# Design and Access Statement Addendum-Plot A

ON00AZ-FPA-XX-XX-RP-A-000008-P01

This Design and Access Statement (DAS) addendum has been prepared to set out proposed amendments to 'Plot A' at Oxford North, it should be read alongside the Design and Access Statement from the original submission. The amendments have been developed following a period of design development with input from the design team and specialist contractors.

#### 2.1 Level 3 extension

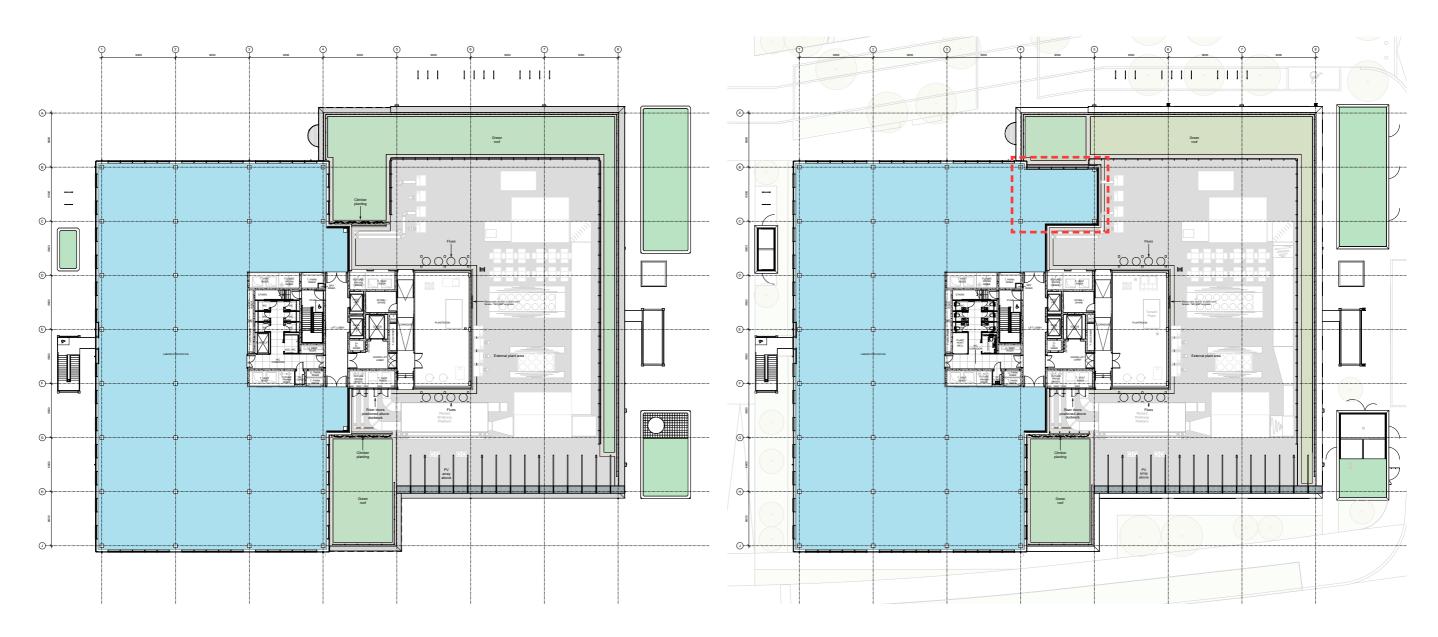
It is proposed to extend the level 3 floorplate by approximately 60sqm to provide additional space with views over the central landscape.

The green roof area lost at level 3 as a result of the change is compensated for by pulling back the line of the adjacent plant screen to provide additional green roof, and through a sedum roof build-up at level 4 above the extension.

The extension has been designed to follow the original design intent - sitting within the glazed central portion of the building to maintain the two stepped 'block' forms.
